# Rezoning Transportation Analysis

Petition Number: 2021-089

## Revision Log:

Date	Description
08-20-2021	First Review (WB)

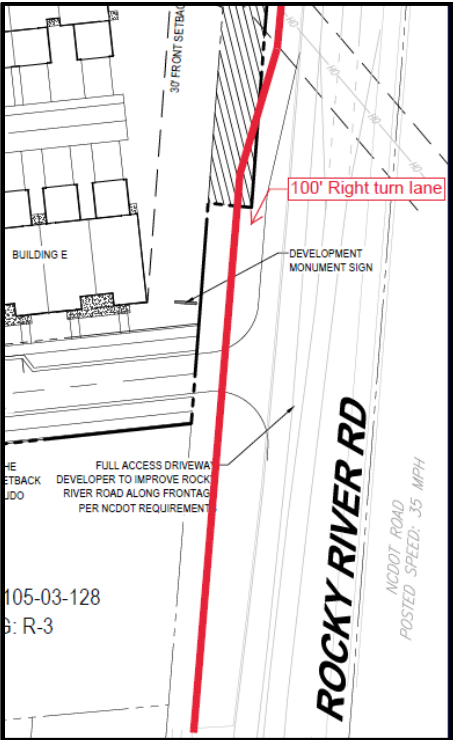
3. Revise site plan and conditional note(s) to commit to dedicate 50' (minimum) right-of-way from the Rocky River Road centerline. The site plan shall label and dimension the right-of-way from the road centerline.

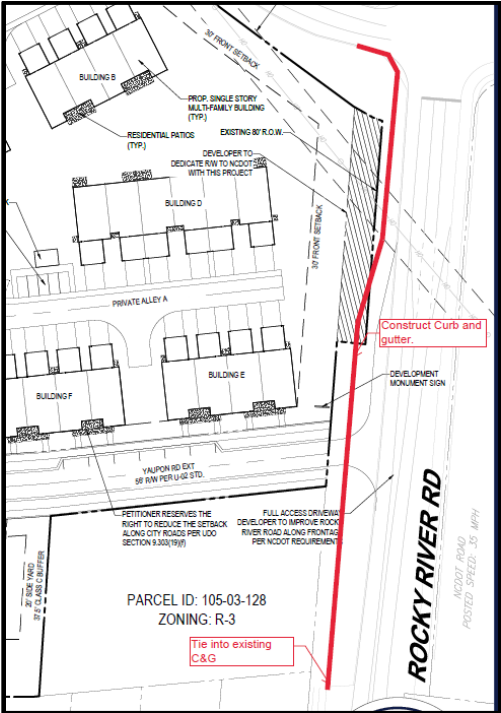
5. Site plan and conditional note(s) revisions are needed to commit to providing a 100' right turn lane at the site's access on Rocky River Road per the NCDOT's standards. The proposed right turn lane should be dimensioned.

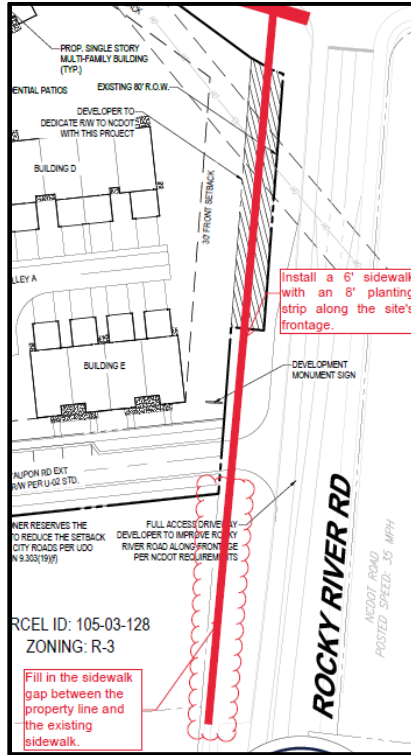
- 6. Site plan and conditional note(s) revisions are needed to commit to construct bicycle facilities by installing the curb and gutter 35' from the Rocky River Road centerline per the Charlotte's BIKE Policy. The proposed curblines should match what has been set up west of the project.

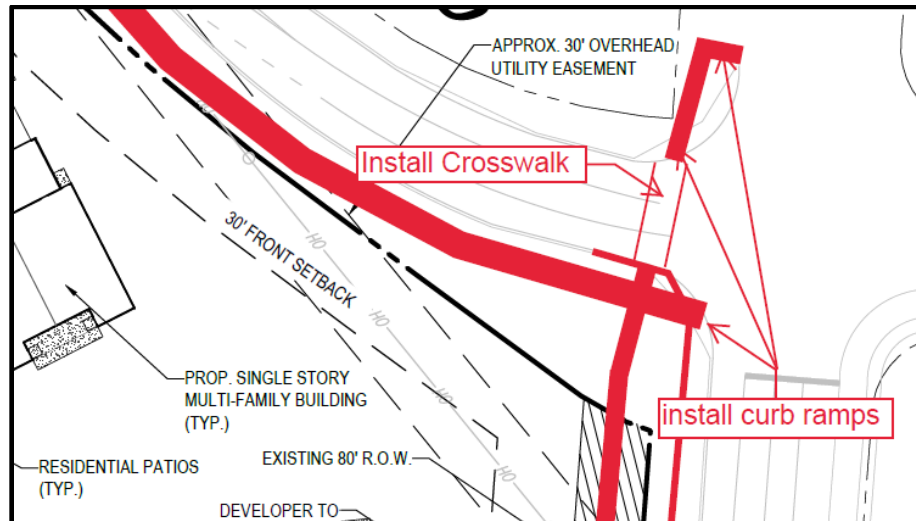
7. Revise site plan and conditional note(s) to commit to construct an 8-foot planting strip, and 6-foot sidewalk on Rocky River Road per Chapter 20. Tie into the existing sidewalk west of the site to provide pedestrian connectivity and accessibility in accordance with PROWAG and the Charlotte Walks plan. The site plan shall label and dimension both items from the back of curb and gutter.

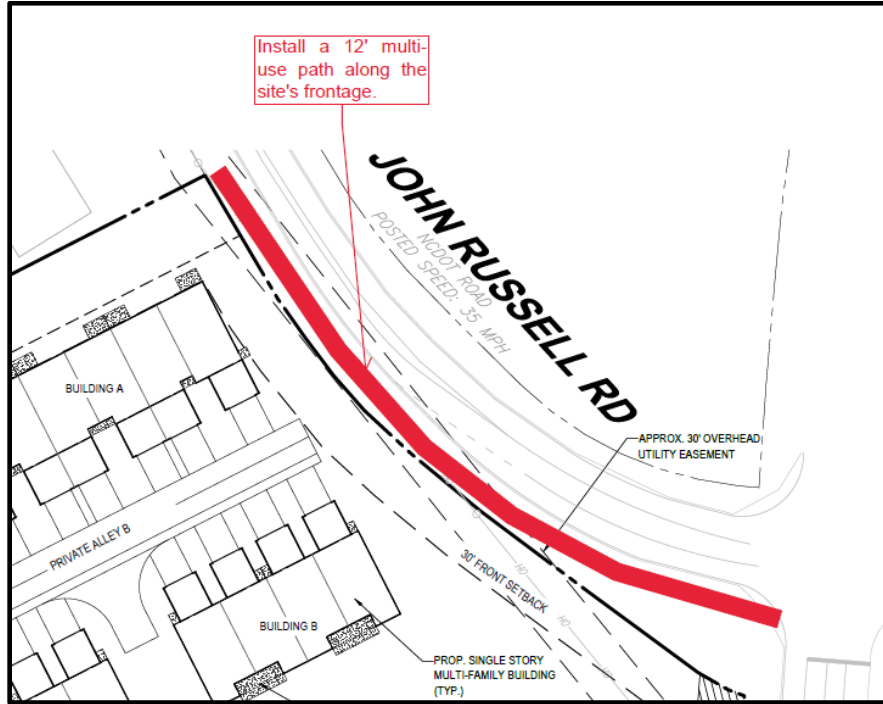
8. Revise site plan and conditional note(s) to commit to construct accessible ramps and a crosswalk at the John Russel Road Intersection to provide accessibility in accordance with PROWAG and ADA. The site plan shall label and dimension all items.

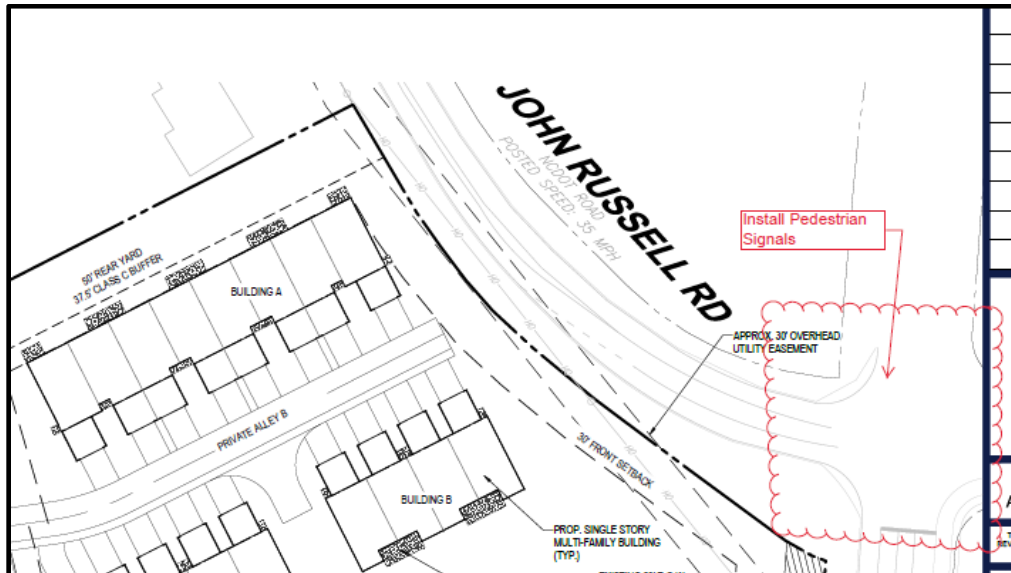
9. Site plan and conditional note(s) revisions are needed to commit to construct pedestrian and bicycle facilities by installing a 12' multi-use path along the John Russel Road Frontage in accordance with the Charlotte BIKES Policy.

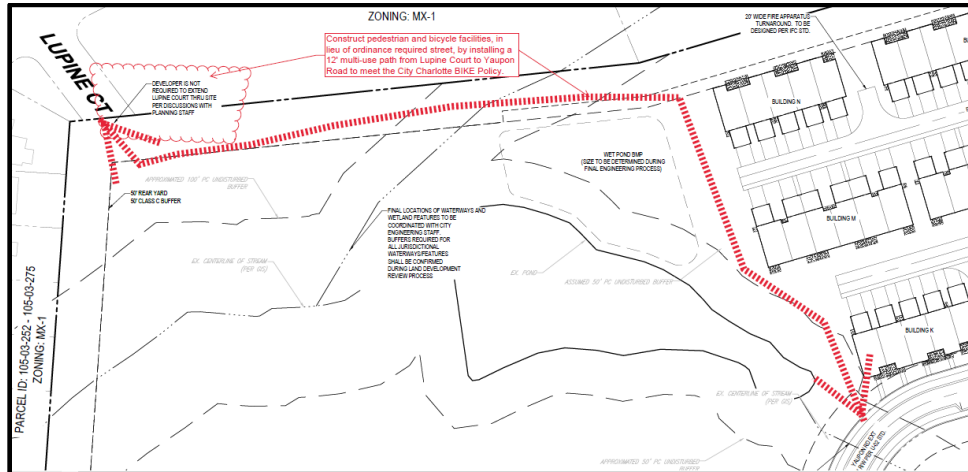
10. Site plan and conditional note(s) revisions are needed to commit to upgrade the pedestrian signal equipment at the John Russel Road and Rocky River Road intersection to meet PROWAG and ADA standards. The pedestrian signal upgrade will include APS installation and the relocation of pedestrian signals off existing wood pole
